**SOUTH DAKOTA**  
**WATER PERMIT NO. 5945-3**

DRY LAKE  
WATERFOWL PRODUCTION AREA  
BROOKINGS COUNTY, SOUTH DAKOTA

DRY LAKE WPA PROJECT

REPORT ON  
WATER PERMIT APPLICATION NO. 5945-3  
U. S. Fish & Wildlife Service  
June 19, 1996

## Discharge Curve For 50' Sheet Pile Weir

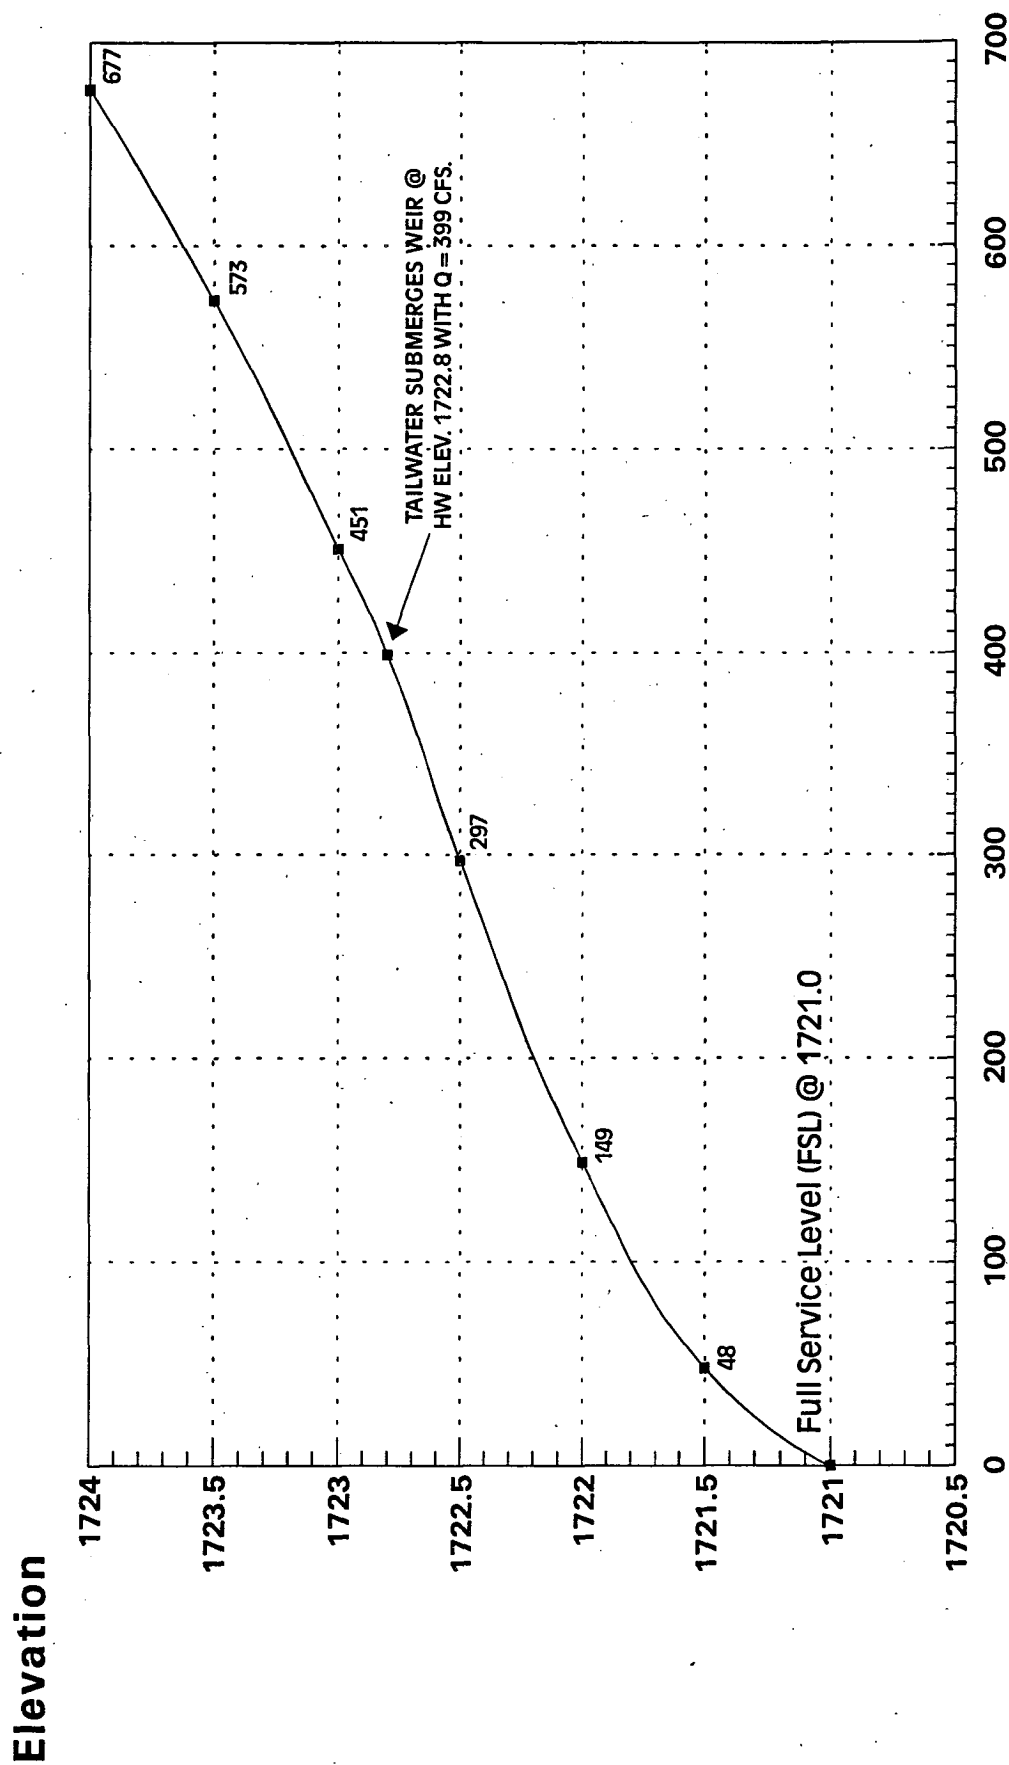
Top of Dam Elev. - 1726  
P. Spillway Elev. - 1721  
Dam Height - 10 ft.

Cat. 3 - Low Hazard Dam

Normal Storage Capacity - 477 Ac-Ft.  
Max. Storage Capacity - 2935 Ac-Ft.

Intermediate size, Cat. 3 Dam - 100 year frequency event  
Minimum Spillway Design

Ducks Unlimited uses the SCS TR-20 model to route a  $Q_{50}$  peak = 929 cfs through the dam with 3.43 feet of freeboard remaining and a  $Q_{100}$  peak = 1296 cfs through the dam with 3.05 feet of freeboard remaining.

Section 74:02:08:09

1. Topo Maps - OK
2. Dam Axis Profile - OK
3. Dam Max X-Sec. - OK
4. Area-Capacity Data - OK
5. Outlet Drawings - OK
6. Spillway Rating Curve - OK
7. Spillway Details - OK
8. Specs. - Std. - OK
9. EPP - N/A - OK
